SPPARC
ARCHITECTURE

Job Title	1602 - 182_184 High Holborn	
Drawing Title	PROPOSED SECTION 01	Client
		Covent Garden Investment S.A.R.L
Scale (at A0)	Date Amended	Amended By
1 : 100@A1	29.03.2017	GK
Checked	Date Created	Drawn By
Checker		Author
Drawing Number & Revision		
HH-P-26-MF-01-01_P4

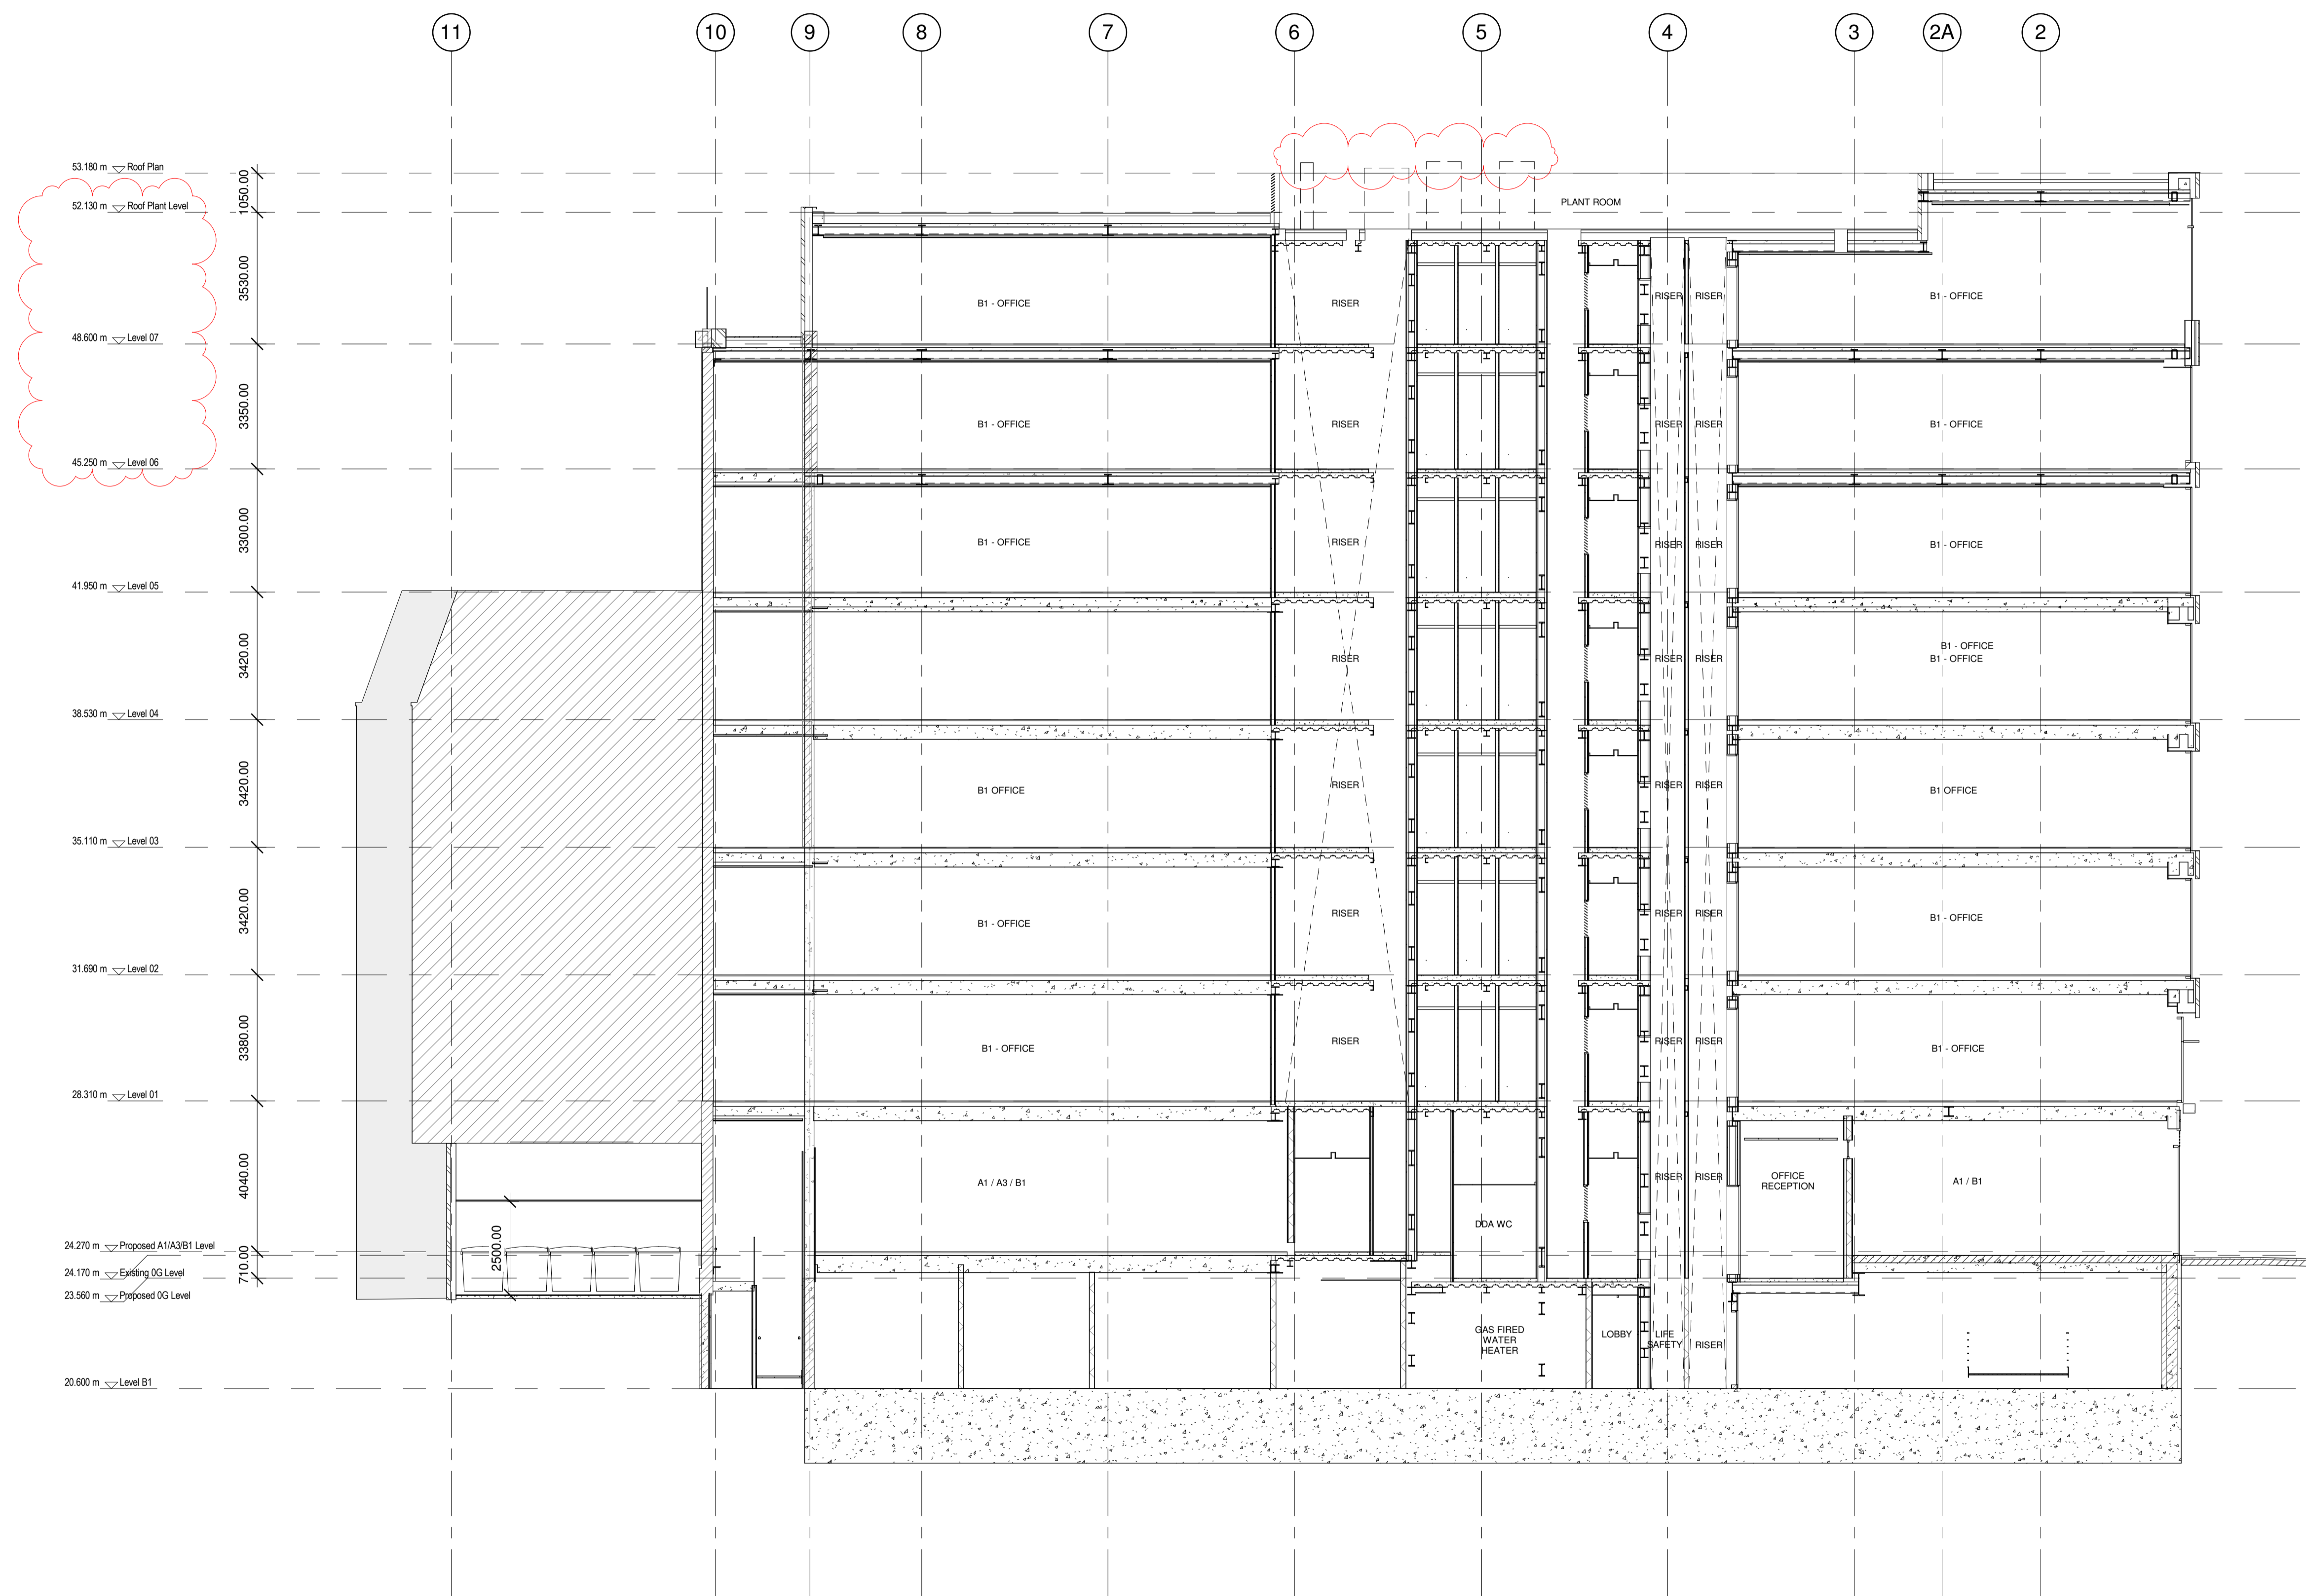
- CHANGES:**
- Roof plant equipment sits 300mm higher than plant enclosure.
 - There is an increased height on levels 6, 7 and Roof Plant in order to accommodate higher clear ceiling heights. Level 6 (FFL) has been increased by 150mm, level 7 (FFL) by 300mm and the roof plant level by 450mm-which is the total increase of the mass in terms of height. The top roof level has remained intact.
